July 1, 2020

**RE: Response to Memorandum Dated 6/29/20
185-193 Lincoln Street and 6 Crow Point Lane – Hingham, MA 02043
Notice of Intent**

PAVEMENT CHANGE AREA SKETCH
7/1/20

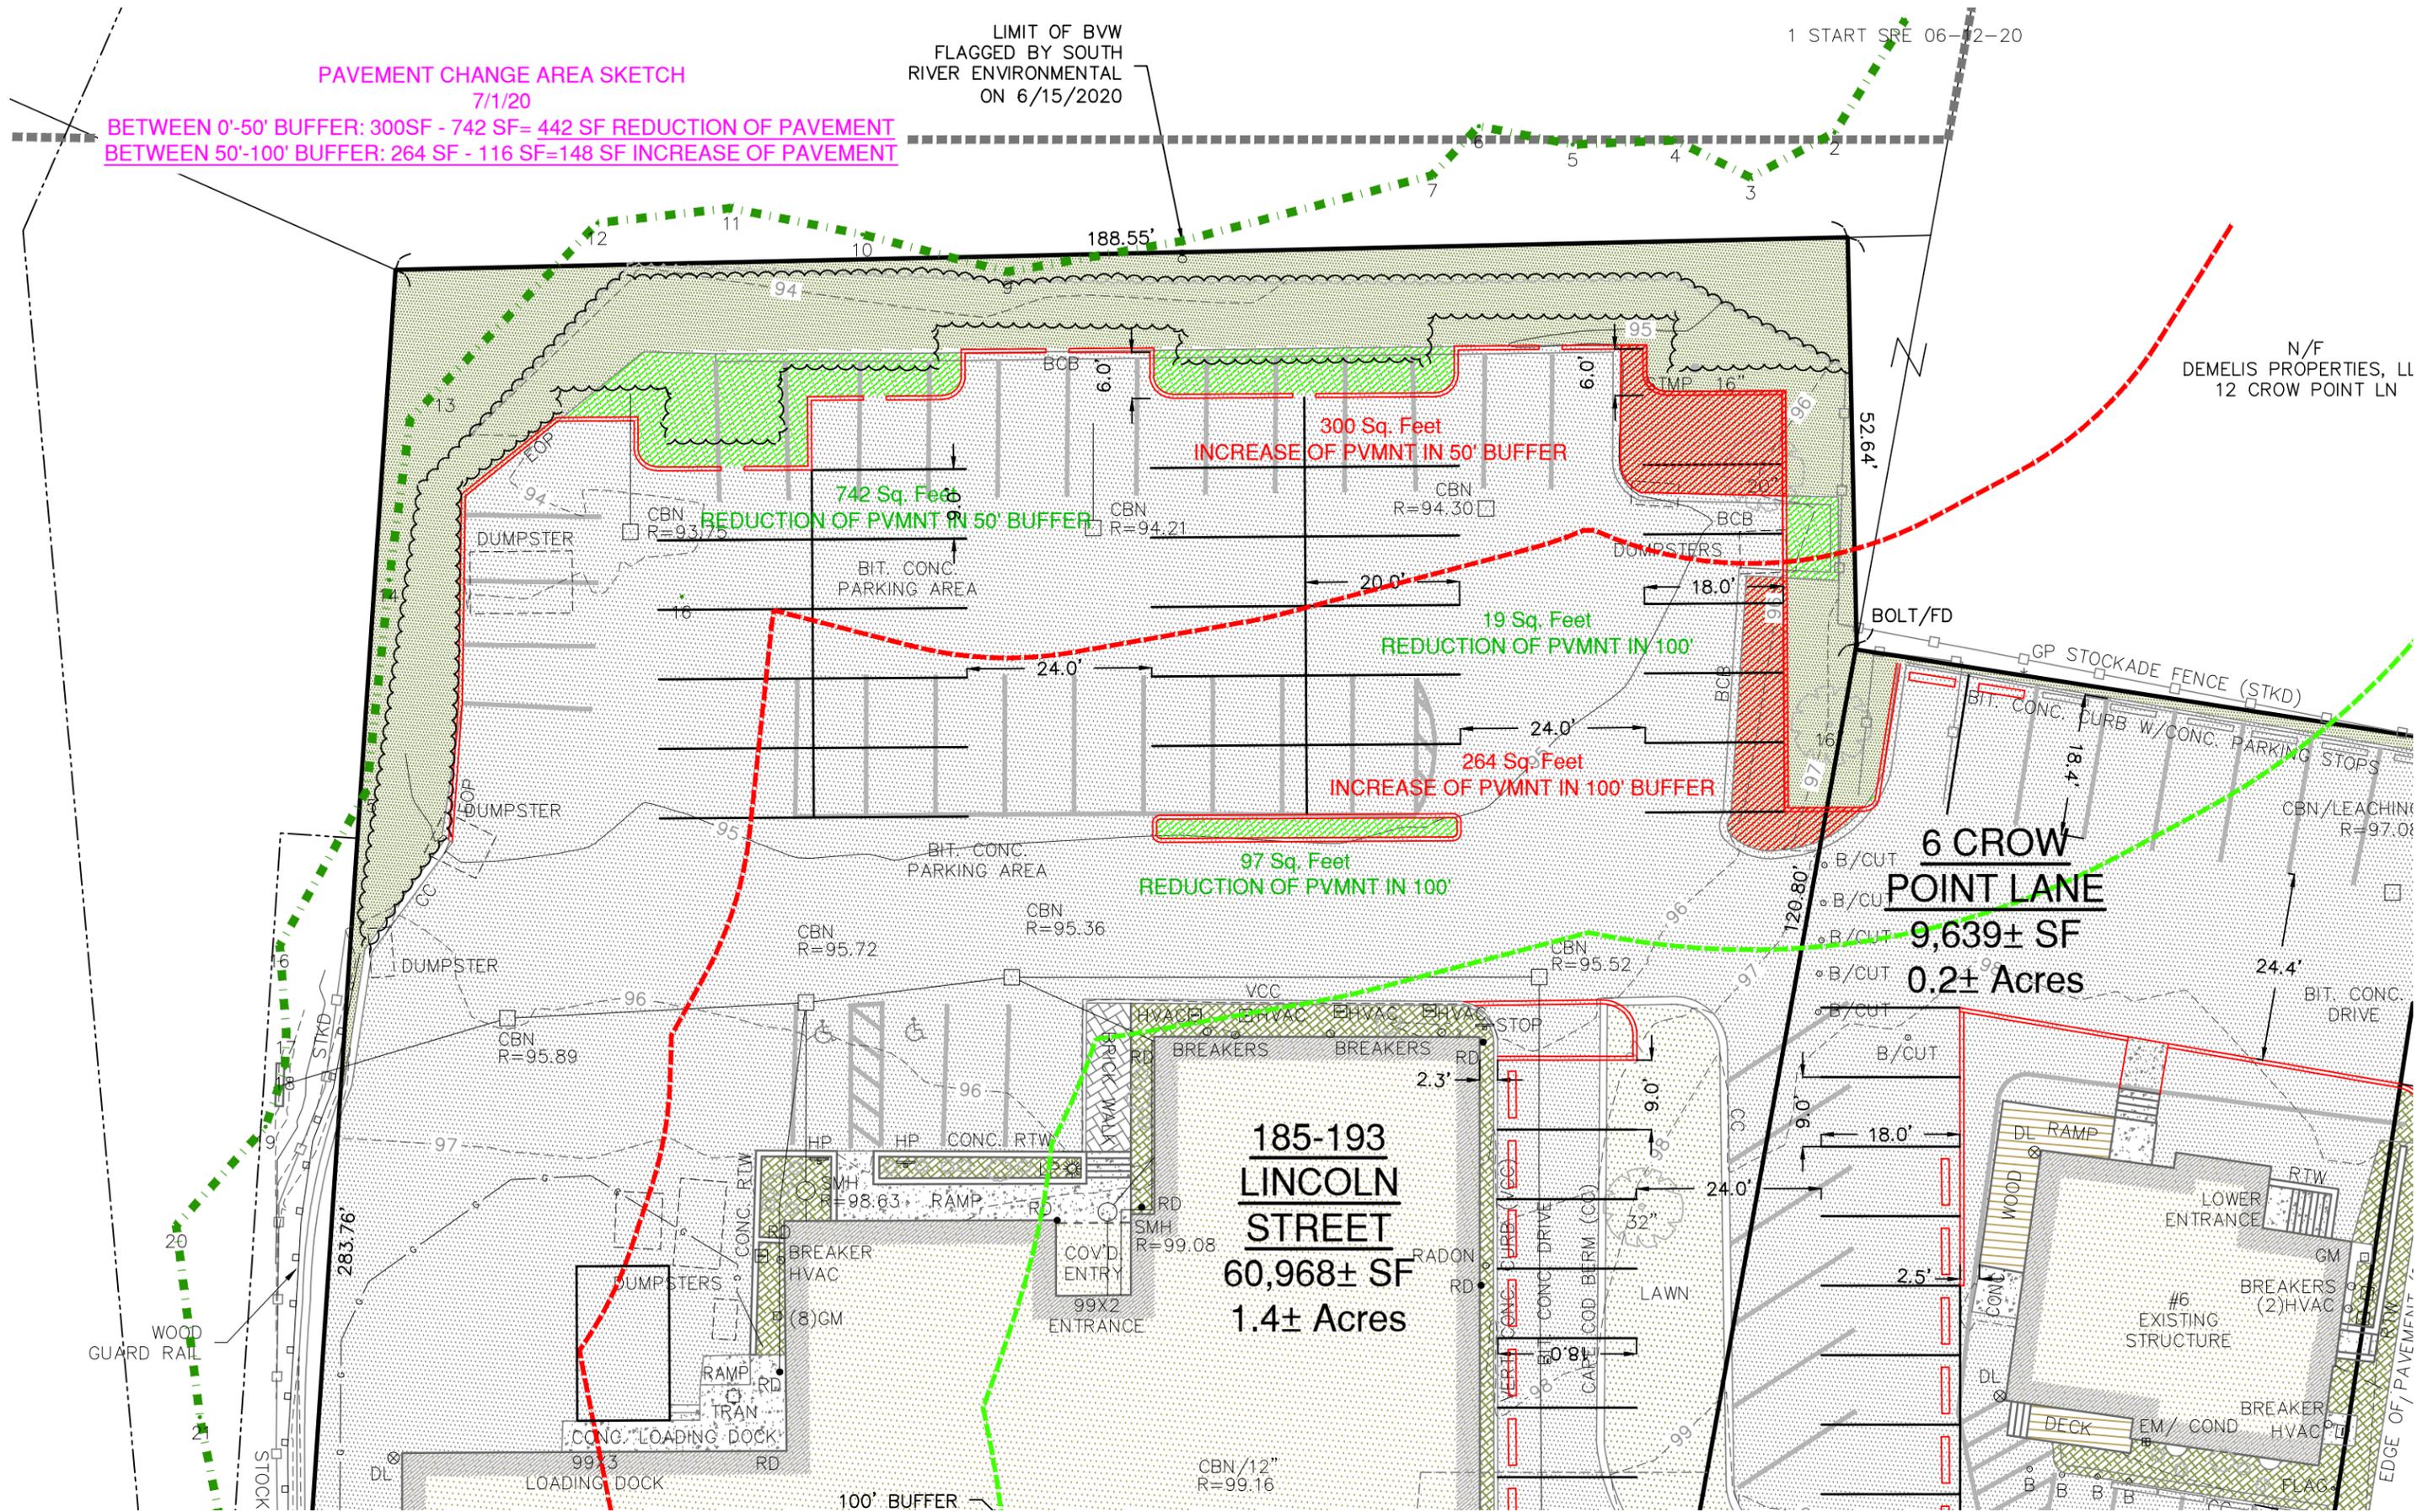
- It seems like most, if not all, of the 179sqft of impervious area being added is in the 50' buffer zone. Can you confirm? *I think it may be between the 50' and 100' but I will check*

and confirm. There is a net decrease of 442 SF of pavement within the 0'-50' Buffer Zone and a net increase of 148 SF between the 50' and 100' Buffer Zones. Please refer to the enclosed sketch for details.

BETWEEN 0'-50' BUFFER: 300SF - 742 SF= 442 SF REDUCTION OF PAVEMENT
BETWEEN 50'-100' BUFFER: 264 SF - 116 SF=148 SF INCREASE OF PAVEMENT
